RE: Application CC #23-26 of 894 Hopmeadow Street, LLC, Owner, Charles Houlihan, Applicant, for a wetland permit to fill +/-3,229 sq. ft. and other site disturbance within the wetland soils and associated activity in the upland review area for the construction of a +/-53,773 sq. ft. mixed-use residential building at 894 Hopmeadow Street, (Assessor's Map H09, Block 227, Lot 004A) Simsbury, CT 06070, zone SC-1.

DESIGN REVIEW MEMORANDUM

Subject: **Engineering Comments – Proposed Redevelopment
#894 Hopmeadow Street**

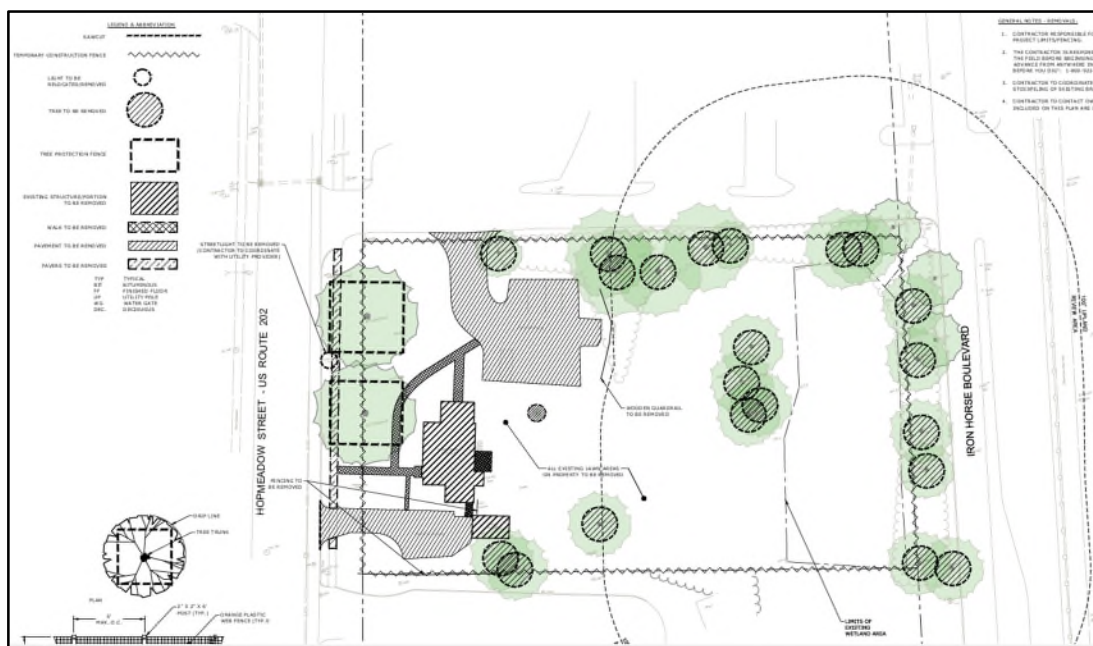
Regulated Activity: The plan requires the filling of approximately 3,223 s.f. of the southern portion of the wetland soil area to provide an access drive to the site from Iron Horse Boulevard, which is shown approximately within the blue circle on the map below. Due to this activity, approximately 33% of the wetland soils will be permanently altered.

LANDSCAPING PLAN

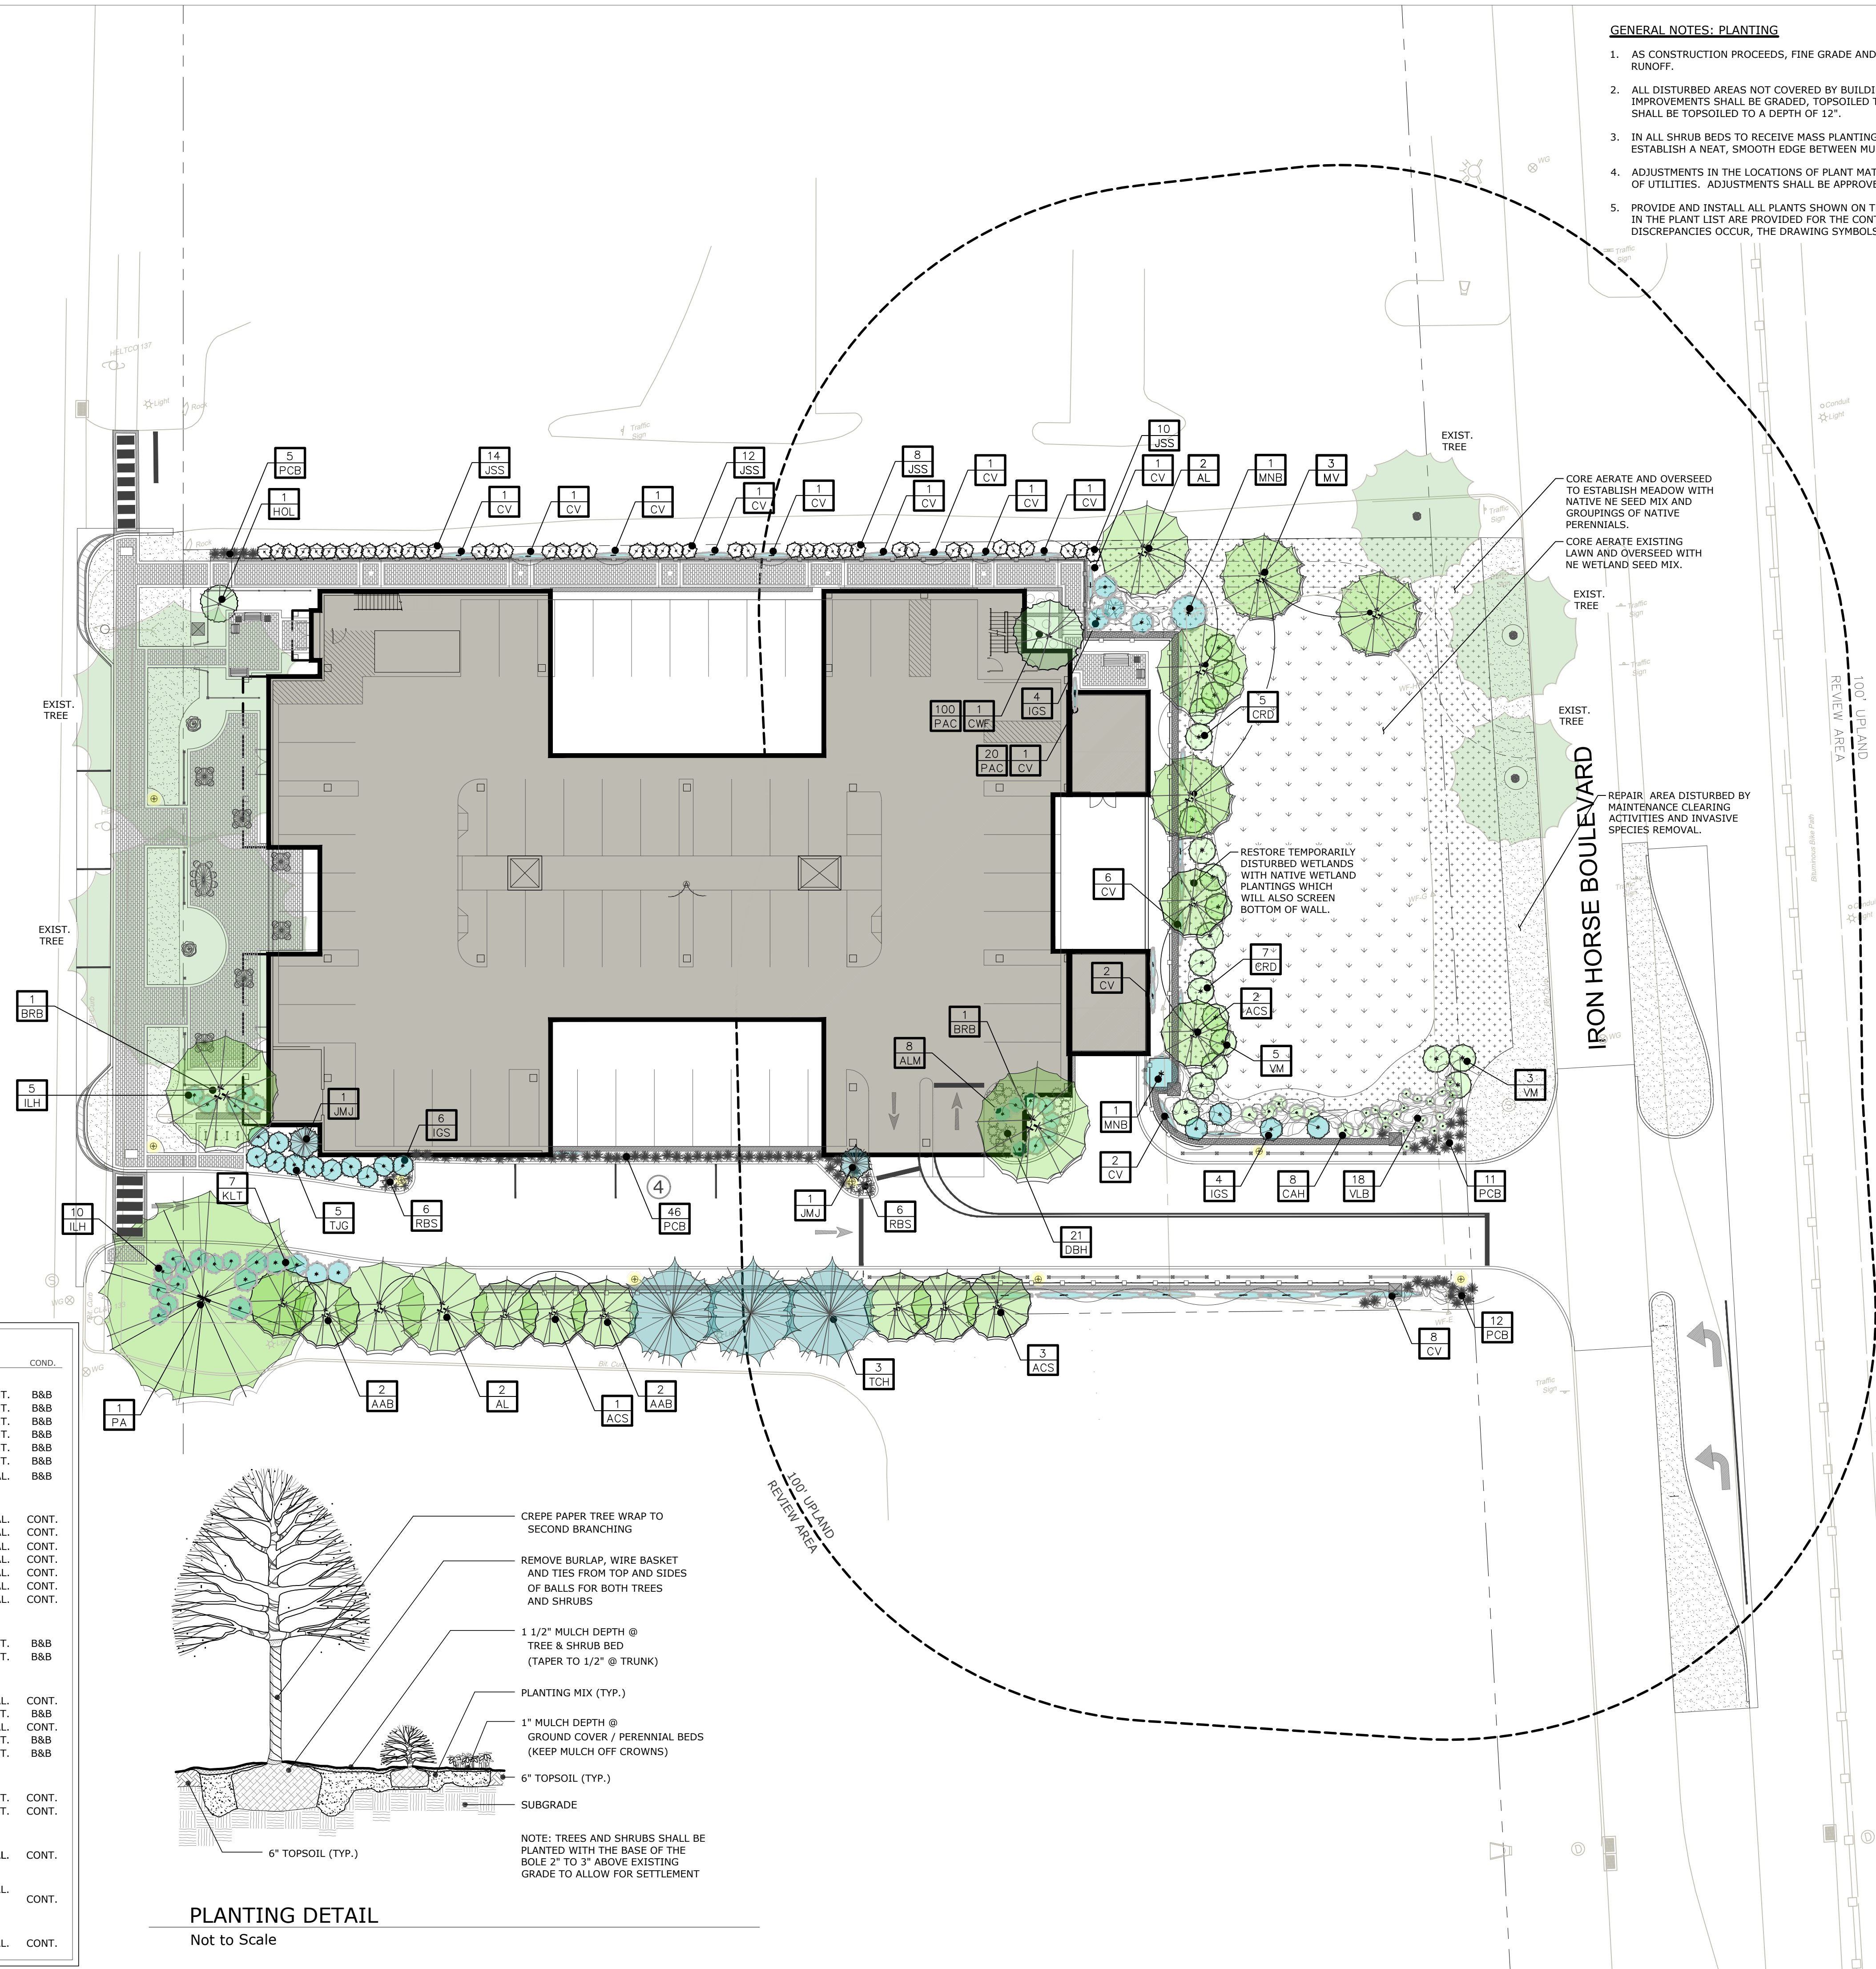
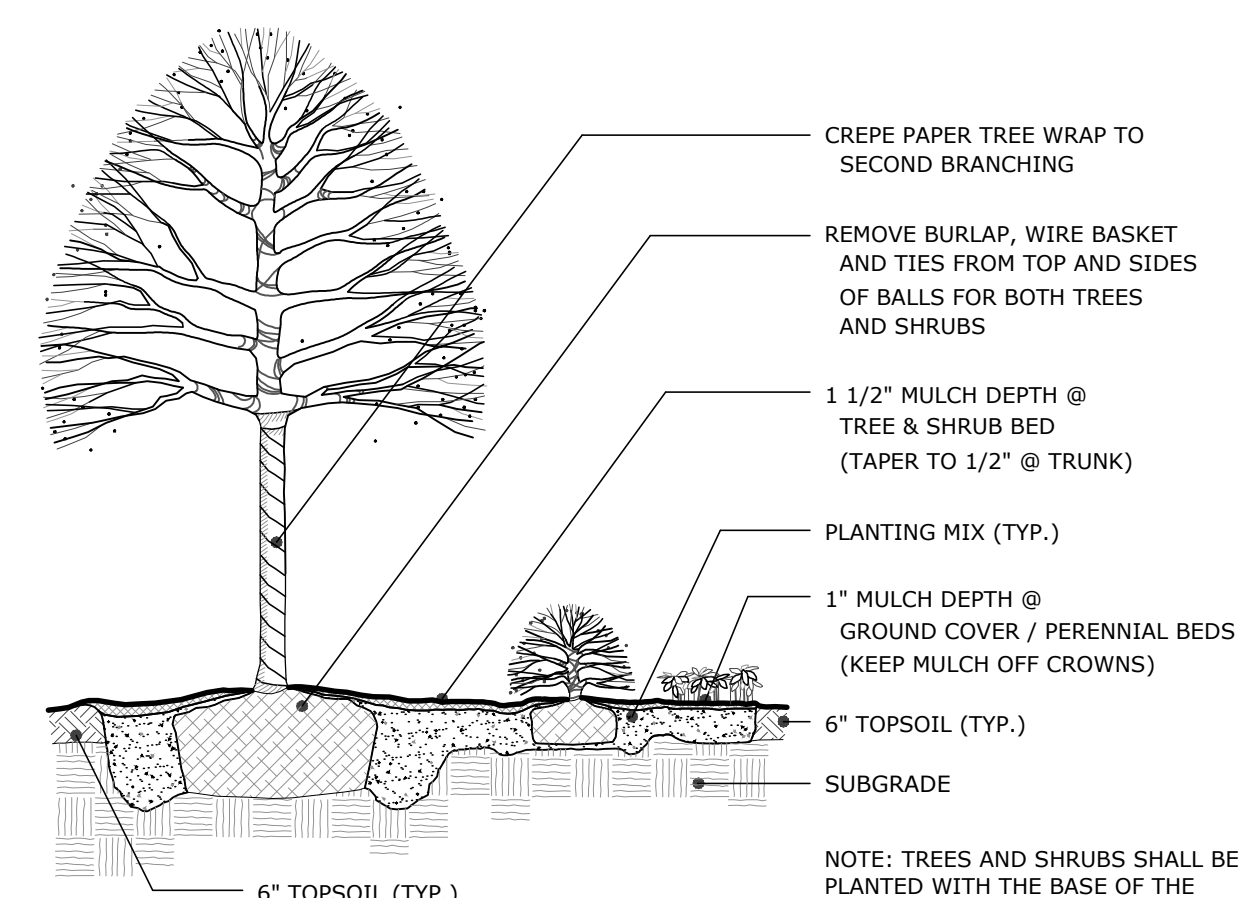
Proposed Mitigation: Soil and erosion control measures are proposed to protect the remaining wetland soils area. Furthermore, an associated planting plan was submitted with the application and proposes to restore disturbed wetlands with native wetland plantings and restore the remaining lawn area and remove invasive species. The proposed landscaping plan was provided in the civil plan set and is shown in the map below (a larger version of this plan can be seen on page L1 of the civil plan set).

It was requested by the commission at the June 20th meeting that native plant species be used to the greatest extent possible. An alternative list of recommended native plantings was provided to the applicant and a response from them was provided along with the revised planting plan and is attached to this report as Attachment 'A'.

894 HOPMEADOW STREET PLANT LIST MODIFICATIONS	
PREVIOUS LIST	REVISED LIST
PAPERBARK MAPLE	DURA HEAT RIVER BIRCH (MULTI-STEM), BETULA NIGRA 'BNMTF'
CORNUS X 'KN30-8' VENUS DOGWOOD	WHITE FRINGETREE, CHIONANTHUS VIRGINICU
ACER GRISEUM	DURA HEAT RIVER BIRCH (MULTI-STEM), BETULA NIGRA 'BNMTF'
JUIPERUS CHINENSIS 'PFITZERIANA COMPACTA' COMPACT PFITZER JUNIPER	LOW SCAPE MOUND, ARONIA MELANOCARPA
JUNIPERUS SCOPULORUM 'MOONGLOW' MOONGLOW JUNIPER	REMAINED SEE NOTE *
SPIREA JAPONICA 'SMNSJMF' DOUBLE PLAY PINK SPIREA	LITTLE HENRY SWEETSPIRE, ITEA VERGINICA 'SPRICH'
CORNUS ALBA 'ELEGANTISSIMA' VARIEGATED TATARIAN DOGWOOD	BAILEY'S RED TWIG DOGWOOD,CORNUS SERICEA 'BAILEYI'
CORNUS ALBA 'REGNZAM' RED GNOME DOGWOOD	BAILEY'S RED TWIG DOGWOOD,CORNUS SERICEA 'BAILEYI'
HYDRANGEA PANICULATA 'TREE FORM' TREE FORM HYDREANDEA	HYDRANGEA QUERCIFOLIA, FOTHERGILLA
HYDRANGEA PETIOLARIS CLIMBING HYDRANGEA	WOODBINE,CLEMATIS PANICULATA

ABIES CONCOLOR WHITE FIR	CANADIAN HEMLOCK, TSUGA CANADENSIS
JUNIPERUS SCOPULORUM 'SKYROCKET' SKYROCKET JUNIPER	REMAINED SEE NOTE *
ILEX MESERVEAE 'BLUE PRINCE / PRINCESS'	NORTHERN BAYBERRY, MYRICA PENNSYLVANICA
HOSTA 'STAINED GLASS' STAINED GLASS HOSTA	CHRISTMAS FERN, POLYSTICHUM ACROSTICHOIDES
HEMEROCALLIS 'MARY TODD'	CUTLEAF BLEEDING HEART, DICENTRA EXIMIA
NEPTA FASSENII 'WALKERS LOW' WALKERS LOW CATMINT	DWARF BLACK EYED SUSAN, RUDBECKIA FULGIDA FULGIDA
COMMON PERIWINKLE VINCA MINOR INVASIVE TENDANCIES	CHRISTMAS FERN, POLYSTICHUM ACROSTICHOIDES
CLEMATIS PANICULATA SWEET AUTUMN CLEMATIS POTENTIALLY INVASIVE	WOODBINE, CLEMATIS PANICULATA

*PLANT NOT REPLACED. PLANT IS INDIGENOUS TO THE COUNTRY AND THE SELECTED PLANT IS MOST SUITABLE FOR THE AREA PROVIDED ALONG THE WALKWAY DUE TO SIZE.
